## **Little Pine Creek II**

### **Monitoring Year 1 of 7**

Subject: Draft MY01 Monitoring Report

Equinox has completed the review of the Little Pine Creek II Draft MY01 Monitoring Report comments. Following are the responses to those comments (in Red)

Integrated CCPV  
MY1  
Little Pine Creek II  
Alleghany County, NC  
Overview

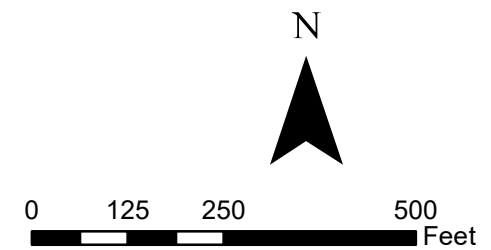
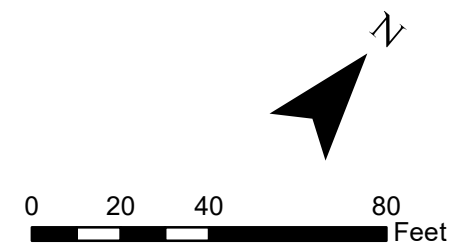
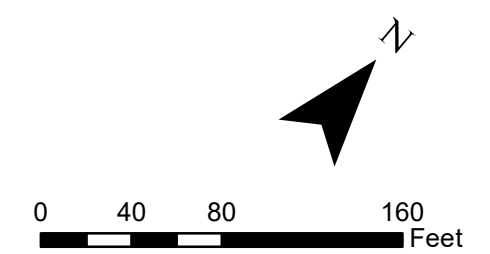
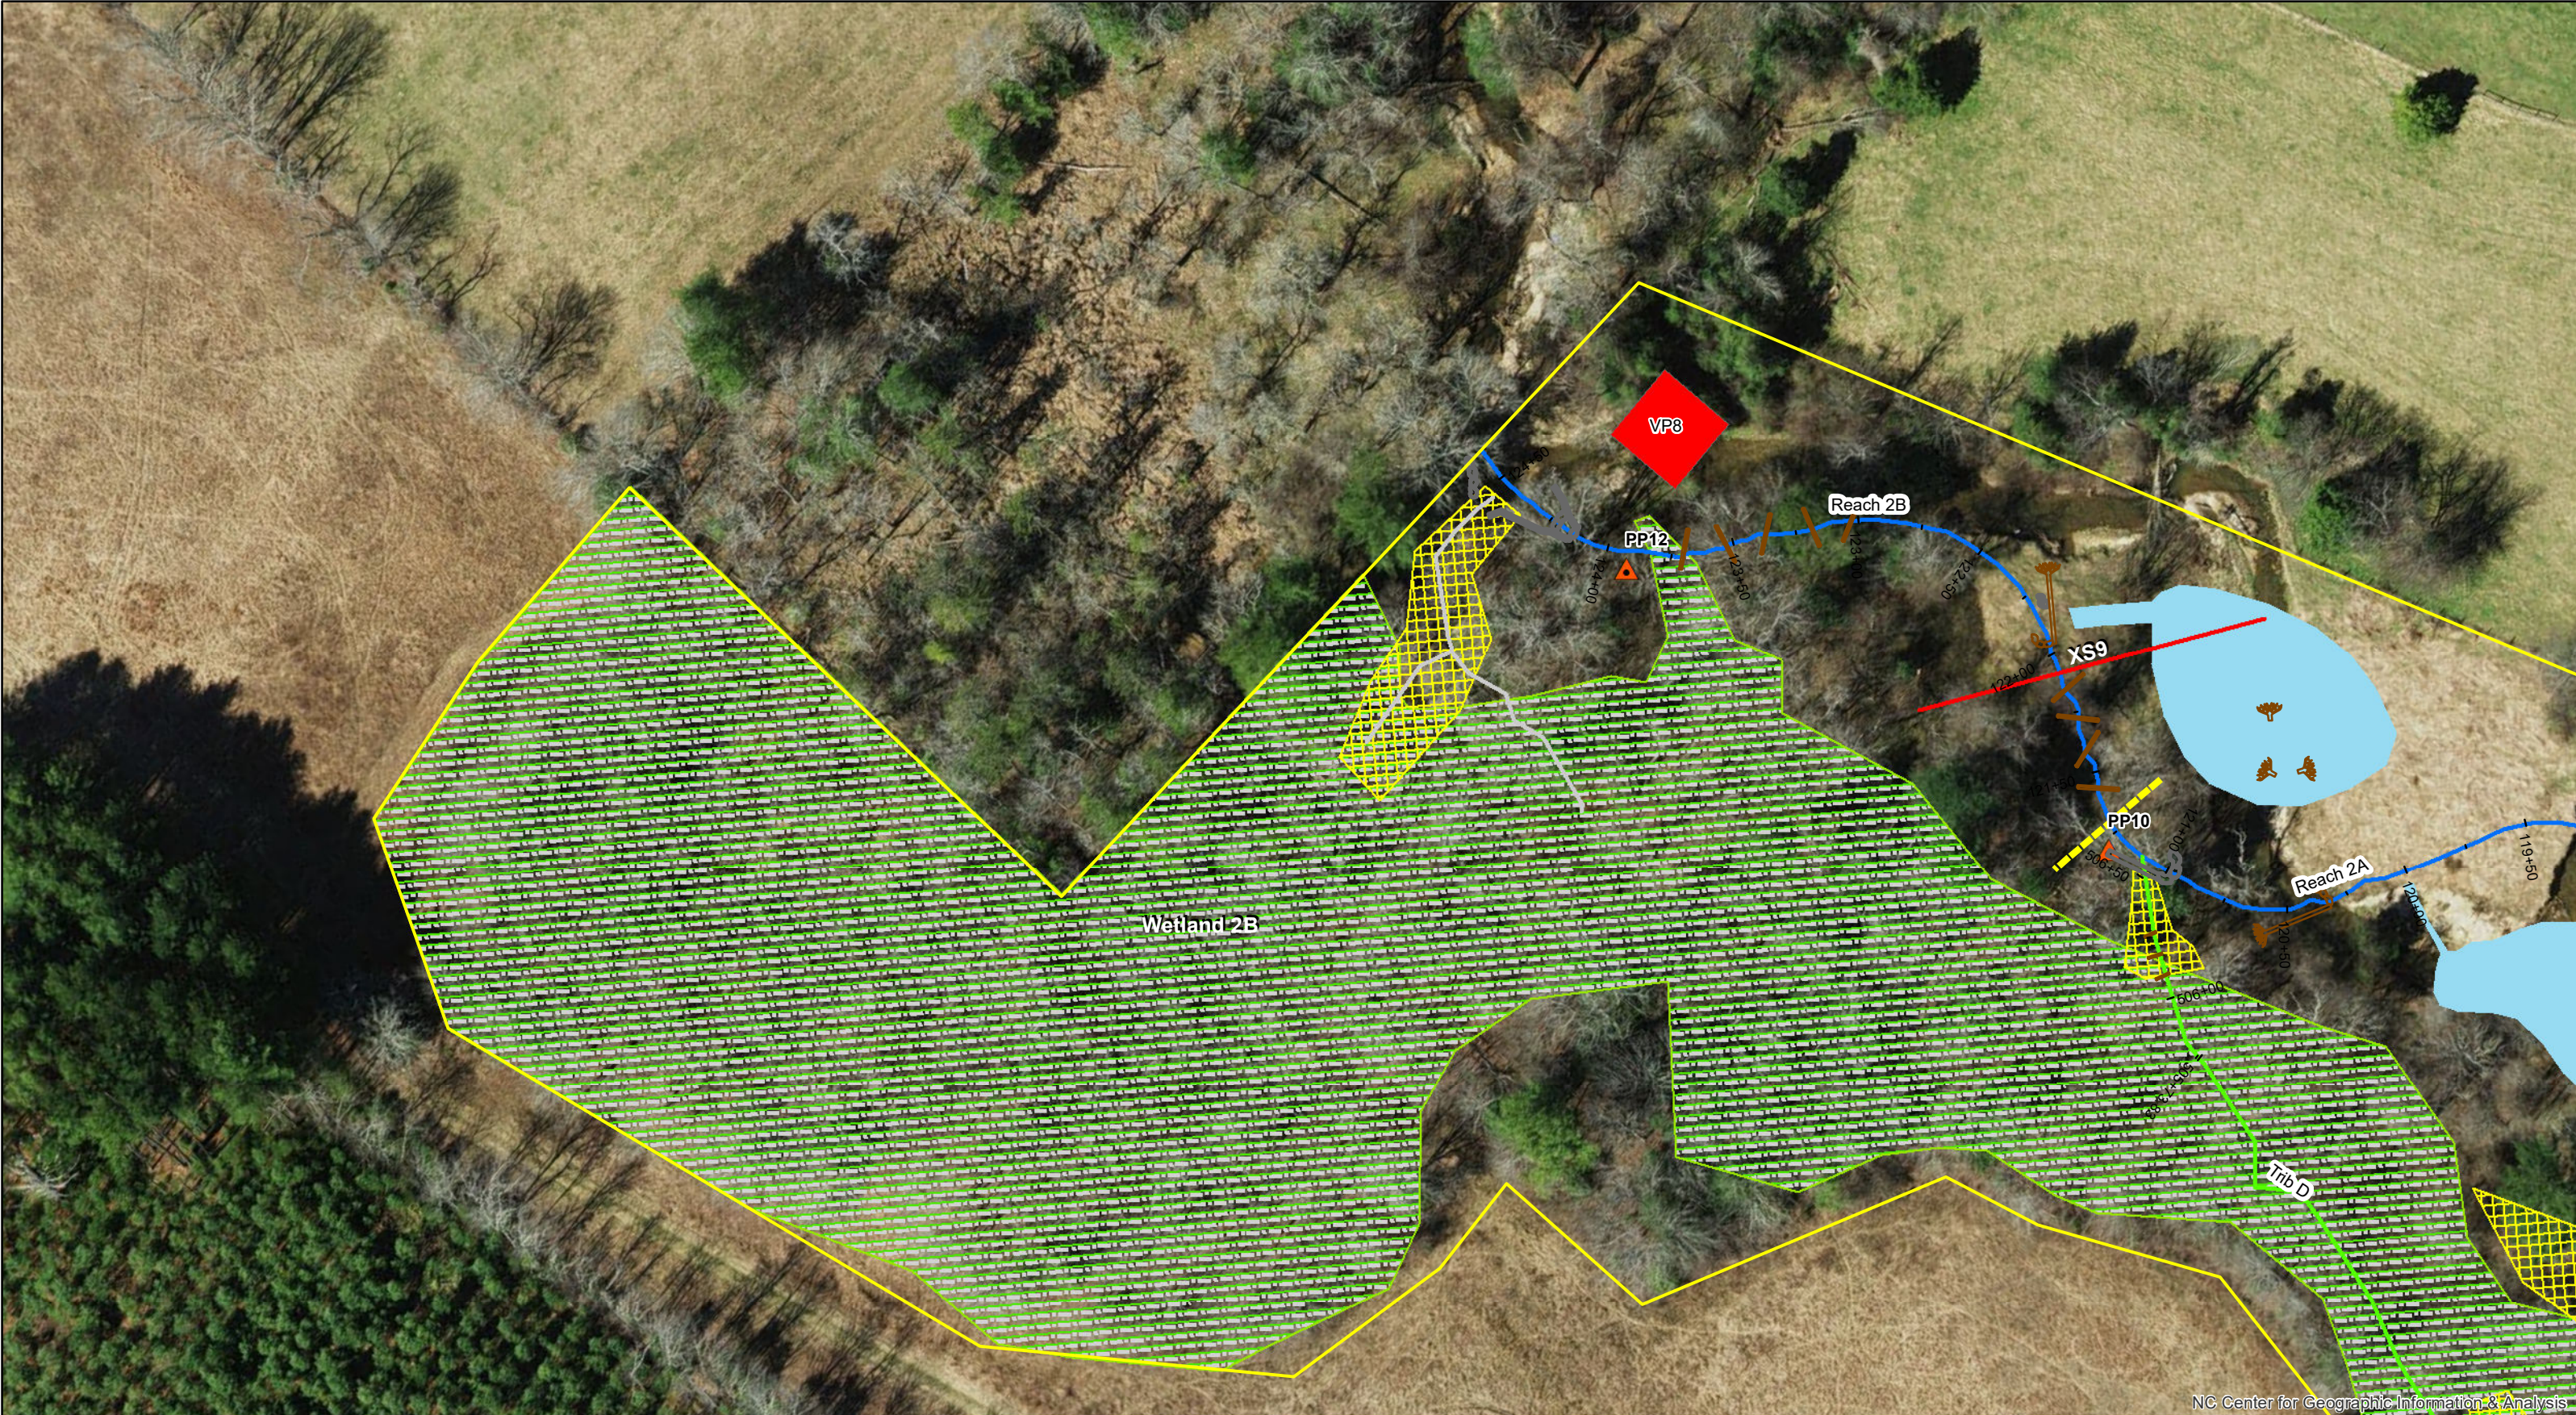
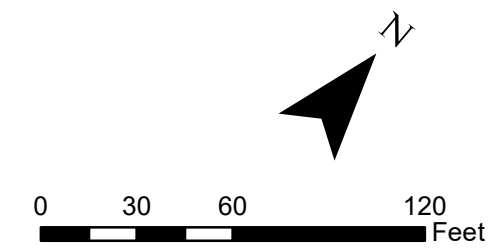
- If possible, please refine invasives polygons to better reflect field conditions; the larger areas shown on the map are not reflective of the scattered invasive occurrences on the ground. Adjust Table 6 accordingly. **Current polygons were reflective of invasive presence on the ground in addition to vines within the woodland. Report text and the CCPV updated to better describe the density and composition of invasive vegetation.**

- Failing vegetation plots should be colored orange or red and captured in the legend. **Failing vegetation plots are colored red.**
- Reach break between LPC 2A and 2B should be shown on the CCPVs. **Reach break inserted.**

- Continuous stage recorders and crest gages are missing from the CCPVs and legend. Please add. **Continuous stage recorders and crest gages added to CCPVs.**

- Please change the color of the OHW to gray/neutral color so as not to conflict with the cross sections. **OHW line color changed to gray.**
